Our Ref: 1194-1-22
Your Ref: DA2023/0775

Re: Council RFI Letter Request for Further Information – Development Application DA2023/0775 2 Bachell Avenue Lidcombe, and Engineering Comments- Traffic and Vehicular Access and DRP panel comments.

This covering letter has been prepared to address Council's RFI letter dated 30th July 2024, Council's email requesting further information dated 29th August 2024 and the Cumberland Design Excellence Panel's comments for the meeting of 19th June 2024.

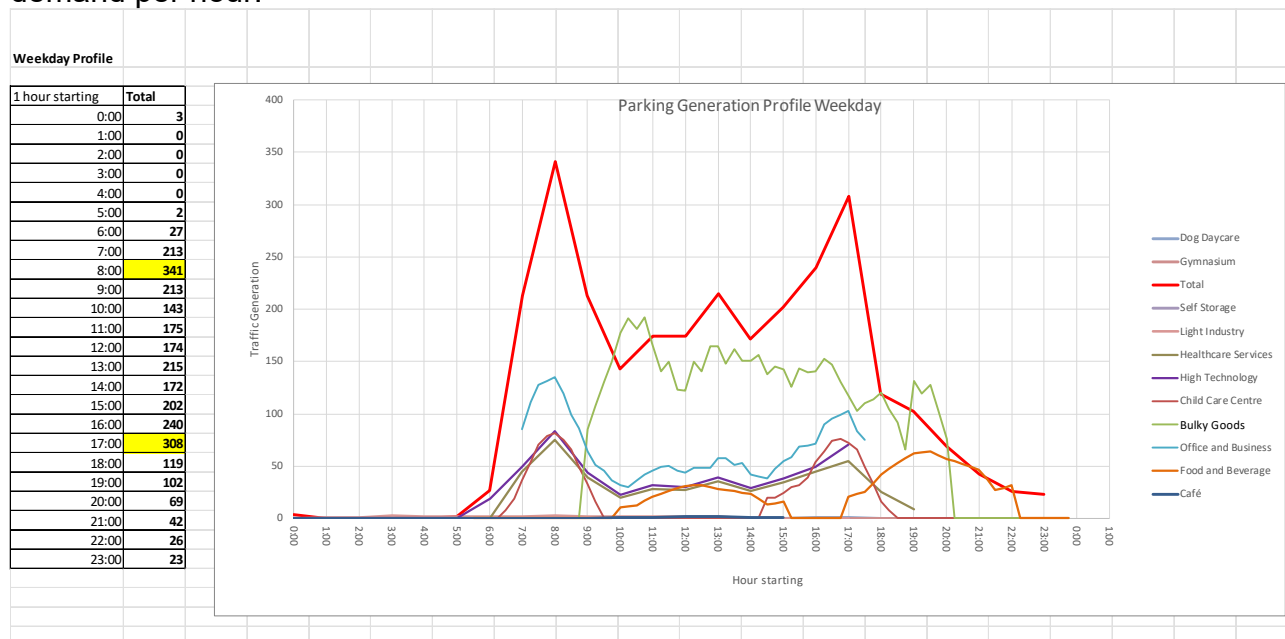
As there is no provision for the visitors parking requirement, the visitors parking must be associated with the relevant land use category and allocated accordingly.

We note that Councils DCP, Part G, identifies visitor parking required for certain uses, the uses provided in the development are not those uses, therefore the DCP does not require a specific quantum of visitor parking, nor does it stipulate that visitor parking must be provided per relevant land use category, or allocated.

Noting that the parking demand varies per use, the appropriate methodology is to create shared visitor parking, This way, office visitor parking, which does not have a high weekend demand, is not sitting idle whilst the specialised retail visitor parking demand is high.

The hourly peak traffic generation demand was analysed in Technical Report 19-23 Appendix E. Parking demand has been analysed based on peak traffic generation demand per hour.

Parking demand on weekdays is calculated as 341 spaces at a peak time of 8:00am using the demand analysis profiles for each use. The updated Traffic and Parking Impact Assessment Report 34-22 Revision D includes Section 3.3.7 Car Parking Profile Demand Analysis.
